Strata Plan 56932 Clisdells Strata Management Locked Bag 30 Rockdale DC, NSW 2215

I am writing on behalf of the owners and residents of Strata Plan 56932, located at 158-164 Princes Highway Arncliffe.

Our location, on the corner of Wickham St and the Princess Highway Arncliffe, is diagonally opposite the Eden Street, Arncliffe Mixed Use Redevelopment.

The below two photos show the outlook from unit no 22 which is located on level 1.

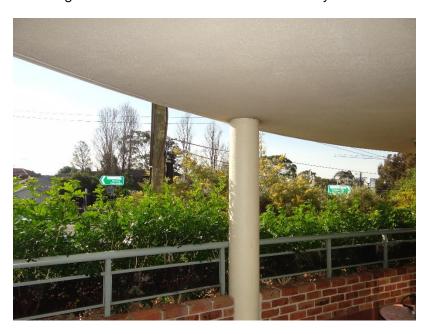
In the first photo, the existing view is of an uninterrupted view of sky.

In the second photo the proposed building form has been blocked out in blue colouring, revealing the almost total loss of views of the sky.

As you can see, when looking to the north the district views will be almost totally obscured by the development in its current proposed form.

Within our building there are at least 8 units that will be similarly affected.

We note that proposed building A is presented as a triangular shape to allow sunlight to penetrate the common open spaces in the centre of the site. We suggest that a similar approach be adopted to Building D so as to create a view poral from the south of the site either between buildings A and D or buildings D and C. The gap does not need to be large, just sufficient to break up the impression of a solid wall of buildings when the site is viewed from the south.

Given the permitted height of the buildings, and as evidenced by the above photos, from all affected units on our site there will be a total loss of views of sky above the proposed buildings. This will adversely impact the lighting in our building. Because of this, we consider it essential that the creation of a 'view portal' be given serious consideration.
